Access Compliance Report

Public Rights-of-Way

(Curb Ramps)

Intersection ID: 24596	Main Street: JARDINIERE_CT	Cross Street: SEQUOIA_RED_LN	Location: NE
ADA ID: 7E0DFFABE500	Ramp Type: PerpDiag	Initial Pass/Fail: Fail	Overall Compliance: No
Severity Score: 12.5			
Codes/Mitigation Info/Possible Solution		Field Measurements/Component Compliance

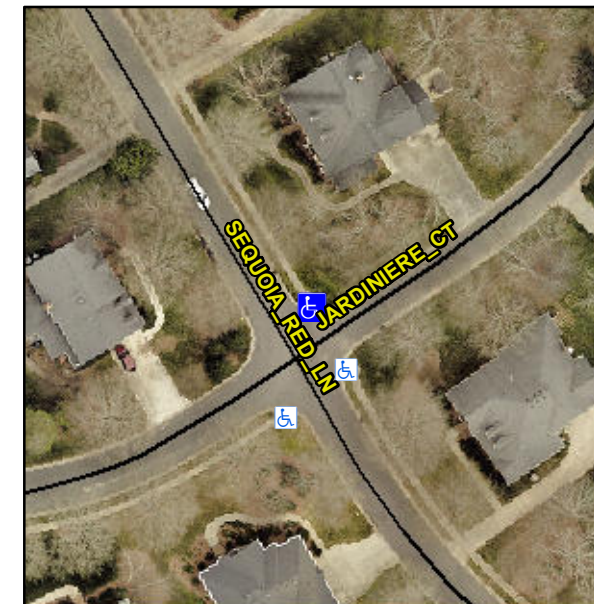
Not Found, R304.5.3

Compliance	Description	Data	Compliance	Description	Data
N/A	Ramp Length (in)	30.5	Yes	Ramp Slope (%)	6.1
Yes	Ramp Width (in)	48.0	No	Ramp XSlope (%)	5.4
N/A	Flare Type LT	N/A	N/A	Flare Type RT	N/A
N/A	Flare Slope LT (%)	N/A	N/A	Flare Slope RT (%)	N/A
N/A	Flare Traversable LT?	N/A	N/A	Flare Traversable RT?	N/A
N/A	Landing Length (in)	N/A	N/A	DWS Provided?	N/A
N/A	Landing Width (in)	N/A	N/A	DWS Contrast?	N/A
N/A	Landing Slope (%)	N/A	N/A	DWS Length (in)	N/A
N/A	Landing X Slope (%)	N/A	N/A	DWS Full Width?	N/A
N/A	Landing Curb? (Y/N)	N/A	N/A	DWS Offset (in)	N/A
N/A	Shared Landing?	N/A			
N/A	Gutter Ponding?	N/A	N/A	Gutter Slope (%)	N/A
N/A	Gutter Lip Ht (in)	1.0	N/A	Gutter X Slope (%)	N/A
N/A	Painted X Walk1?	No	N/A	Painted X Walk2?	No
	X Walk 1 Direction	To SW		X Walk 2 Direction	To S
N/A	X Walk 1 Width (in)	N/A	N/A	X Walk 2 Width (in)	N/A
	X Walk 1 Slope (%)	1.9		X Walk 2 Slope (%)	5.8
	X Walk 1 X Slope (%)	4.8		X Walk 2 X Slope (%)	1.1

Remove & Replace Curb Ramp With Two New Directional Ramps or Equivalent.
